Reviewer #1:

1. This is a well-written paper and presents interesting results evaluating radio occultation (RO) observations from a constellation of eight small commercial satellites developed by Tianjin Yunyao Aerospace Technology. The eight Yunyao satellites produced about 12,000 RO occultations per day over the period May-June 2023. The quality of these observations are evaluated based on mean and standard deviations of Yunyao refractivities computed by comparing with radiosondes and two models, as well as the penetration rates (% of profiles reaching levels near the Earth's surface). This paper is a potentially valuable contribution and should be published, but there are several areas where improvements are needed.

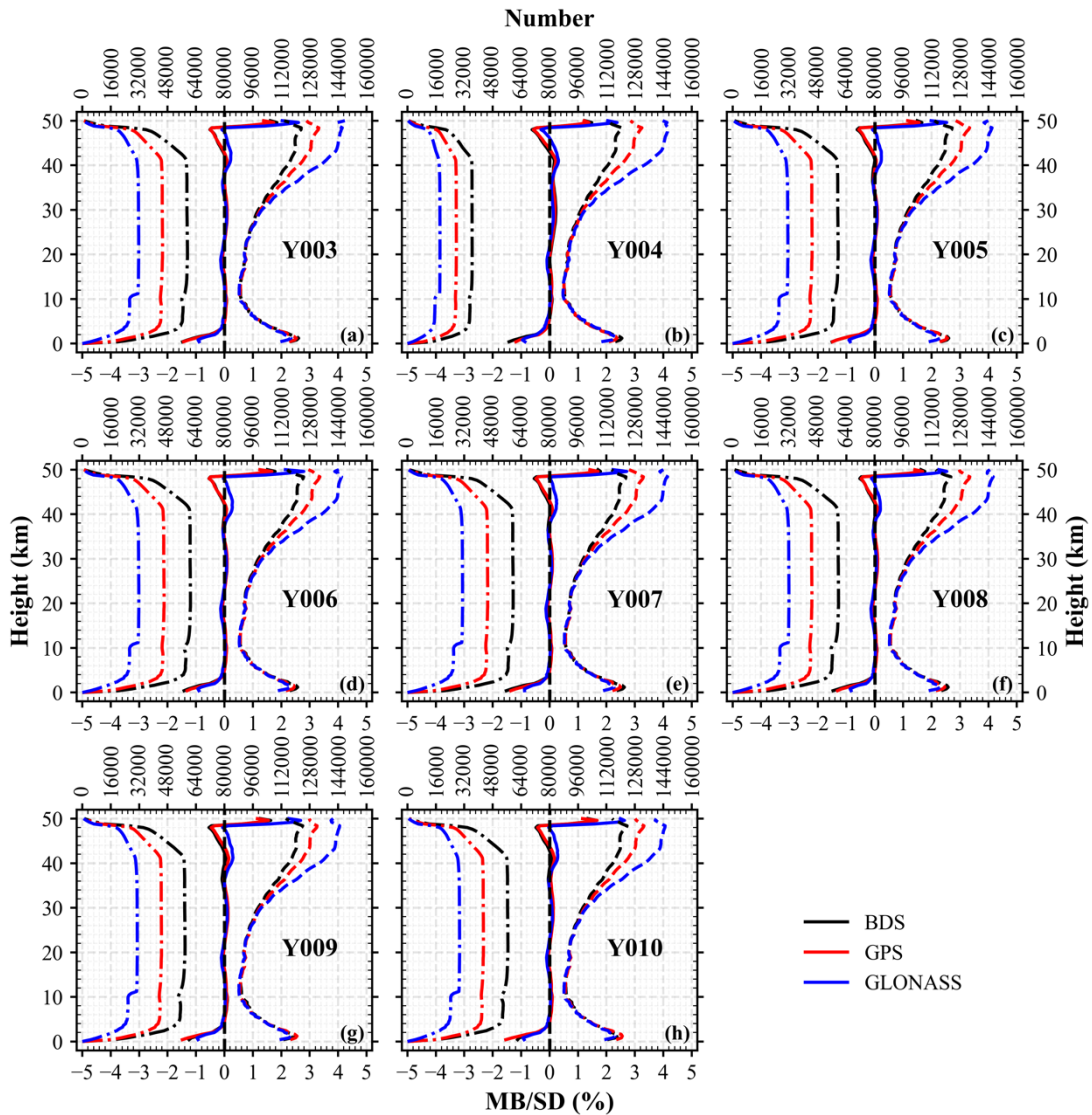
5. It would also be useful to include estimates of the error SD for the refractivity data up to 50-60 km, using the ERA5 and FNL model analyses as the other two datasets (extend Figs. 6-8 up to 50-60 km).

Response: Thank you very much for your suggestions. We apologize for not being able to provide results for the 50–60 km altitude range, as the ERA5 pressure-level data does not include atmospheric information at such high altitudes. The figure below shows the comparison between observations and ERA5 within the 0–50 km altitude range. As shown in the figure, the number of observations available for comparison decreases rapidly in the 40–50 km range, with almost no matching observations near 50 km, resulting in anomalous mean bias calculations. Therefore, we only presented results below 40 km in the manuscript. For Figs. 6–8 in the original manuscript, since we only obtained FNL data for the 26 mandatory levels (from 1000 hPa to 10 hPa), it was challenging to extend the results to higher atmospheric altitudes.
